**RE: APD Crime Paving Improvements
5203 2nd St. NW
Grading and Drainage Plan
Engineer's Stamp Date: 6/16/2022
Hydrology File: F15D019A**

**RE: APD Crime Lab Paving Improvements
Hydrology File: F15D019A**

GRADING PLAN

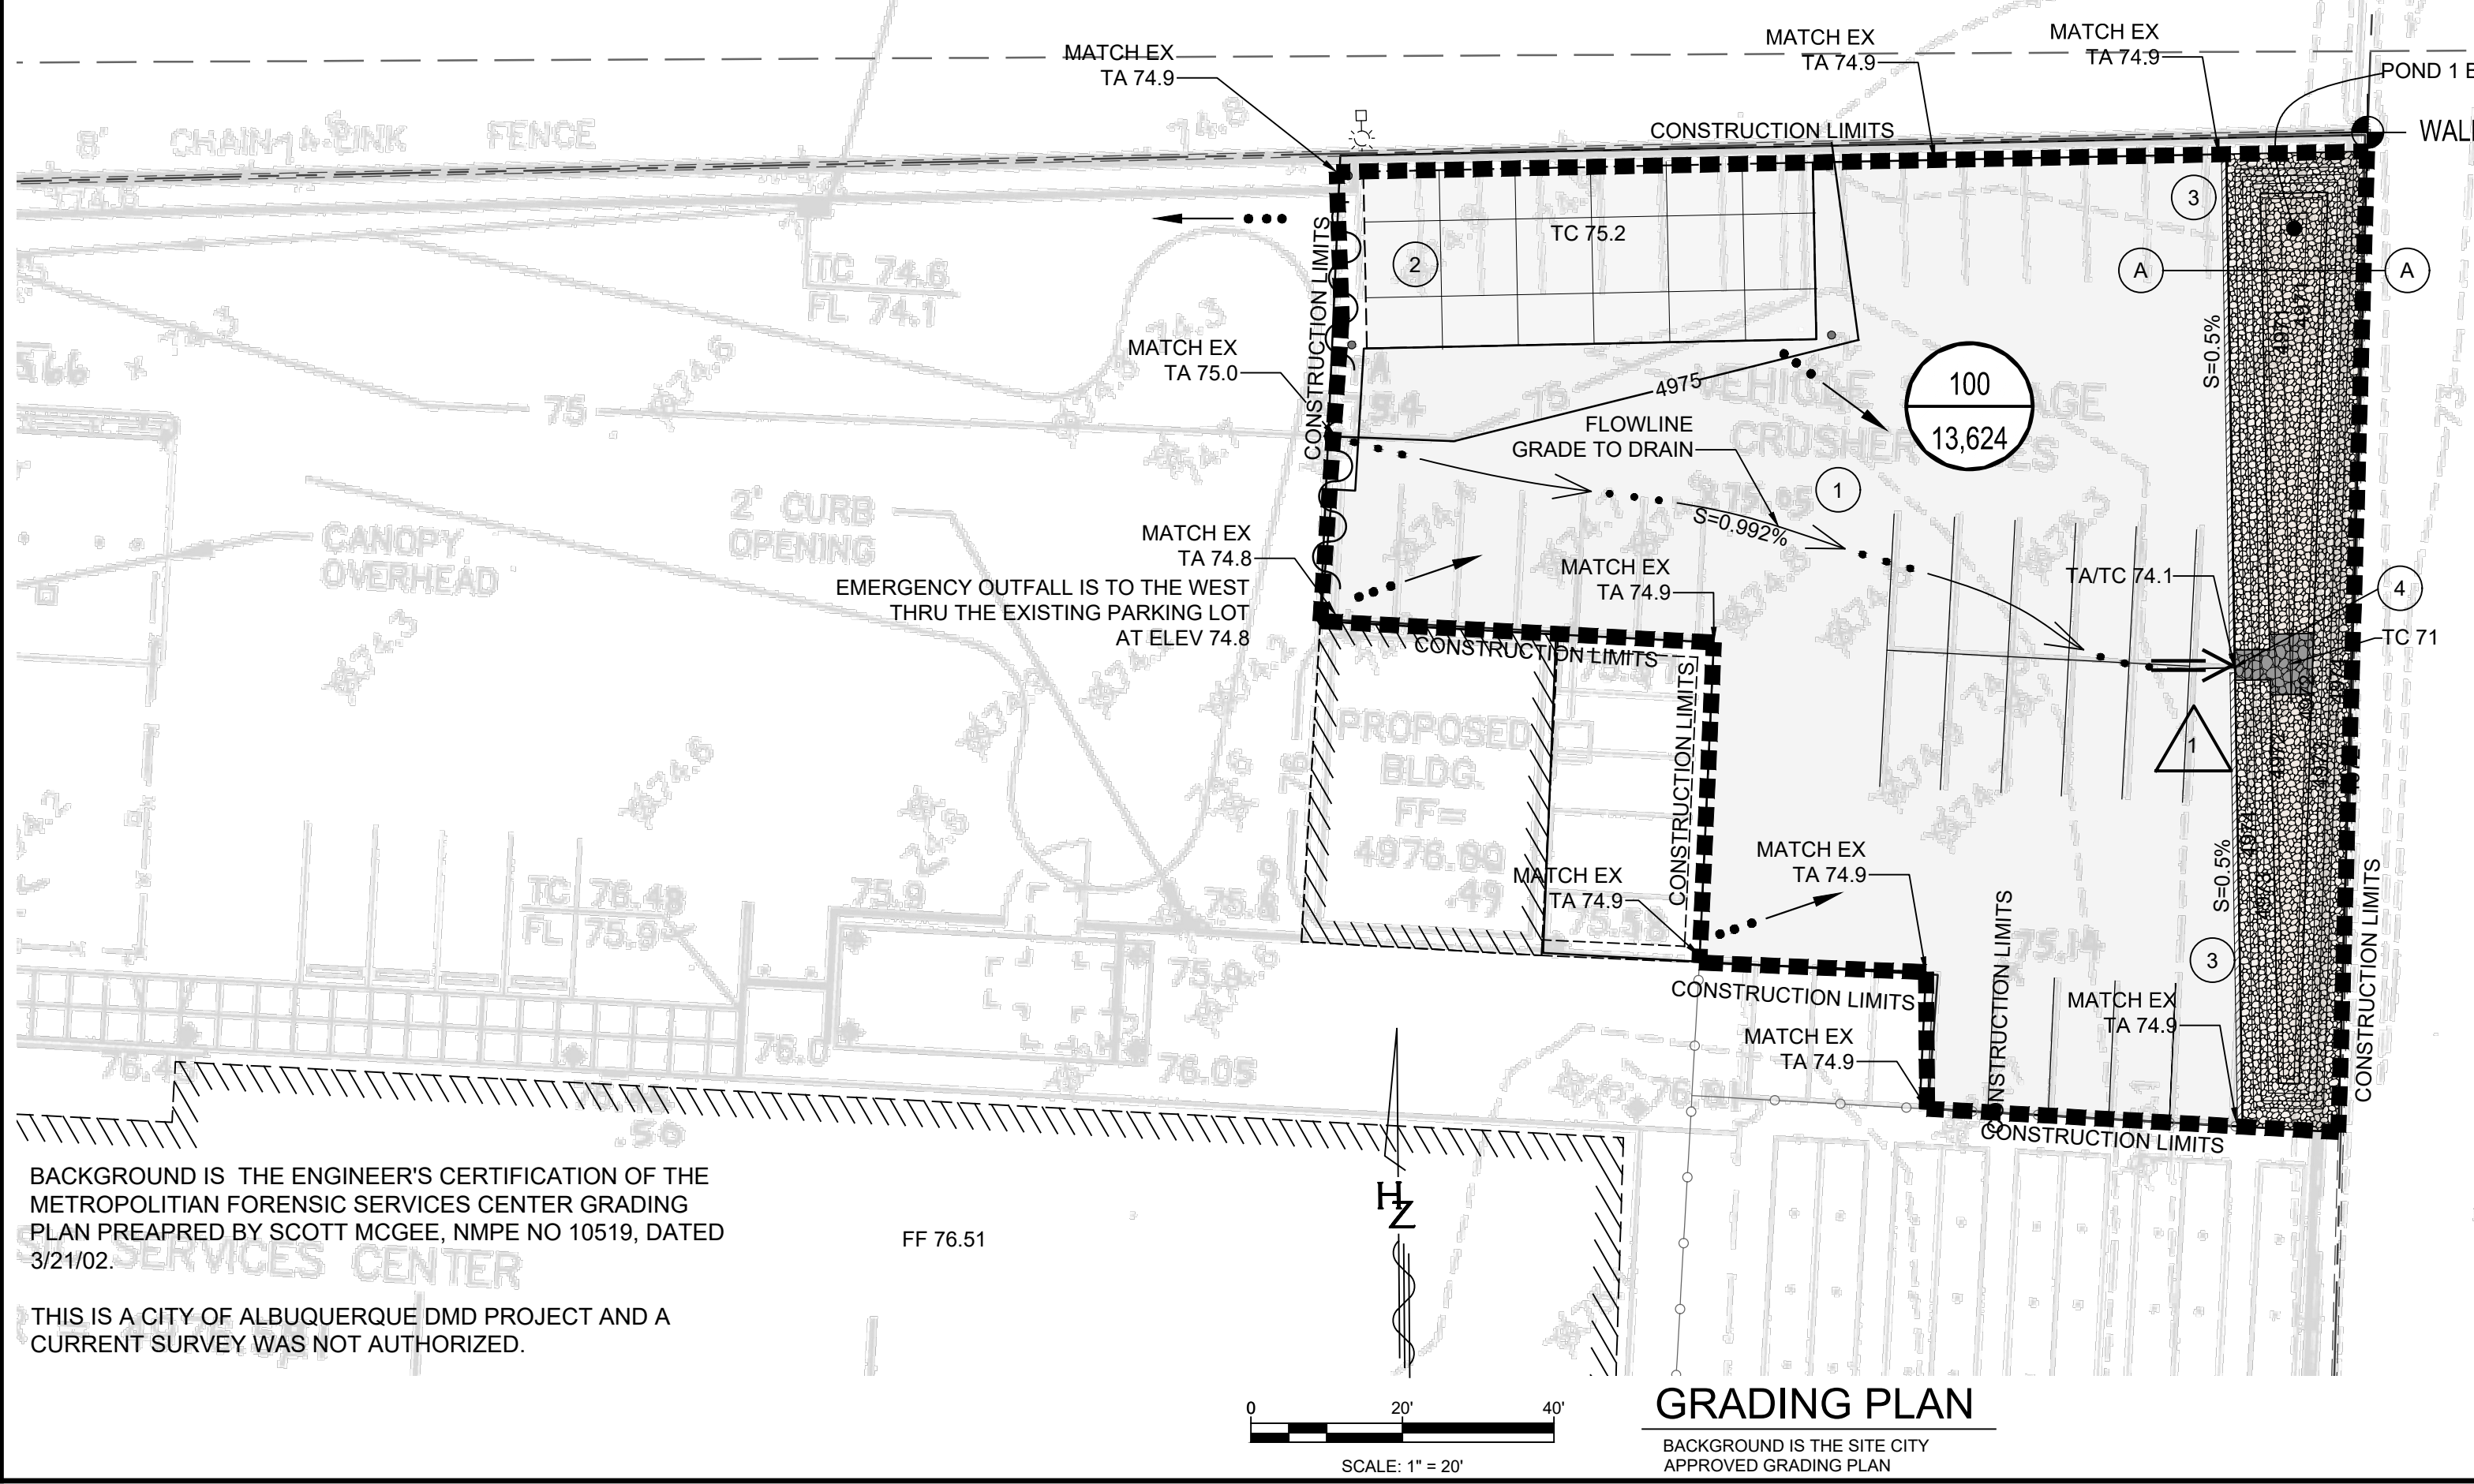
1. *Please use a 1:20 scale.*
Plan View Revised to 1:20.
2. *Please fade back the existing G&D copied over and make it clear with a note that it is present and is for informational purposes.*
Existing G&D faded and a note added in lower left hand corner of plan view.

3. *Please clearly define the basin boundary as the area defined for construction limits of the proposed G&D.*
Construction Limits labeled along boundary.

4. *Please provide a section of the pond and provide elevations (100 year storm, outlet elevation, SWQV elevation, bottom, etc...)*
Section A added on the right corner of the plan containing the requested information.

5. *Please Clearly*
No Response
6. *Please clarify elevation labels and illustrate outfall.*
Labels have been edited for clarity – pond does not discharge.

7. *Please clearly show keyed note 4.*
 - a. *Note 4 is obscured by hatching.*
Hatching is lightened and key note 4 is moved outside of pond.
 - b. *Are there calculations showing the wier opening? Please demonstrate how it will handle the flow going into the pond.*
Calculations Added.

- c. *Provide construction detail of rundown.*
Added reference to City Standard Drawing 2422 with construction note.
8. *Please clearly show a graphic of where pond will discharge.*
Pond does not discharge.

9. *Will there be a curb and gutter on this parking lot or simply edge of pavement? It is unclear the transition and if there is a flowline to get the flow to the rundown.*
Project includes an asphalt curb adjacent to the pond and a flowline within the pavement is now shown.

10. *Please provide benchmark coordinates and tie to the construction limits to the benchmark.*
Reference to City Benchmark provided on left side of plan tie not shown as City DMD did not authorize a project survey.

11. *Please include datum reference.*
Datum reference provided on left side of plan.
12. *Please note this is a retention pond but note where emergency outfall will be.*
Emergency outfall is back thru the existing parking plot to the west.
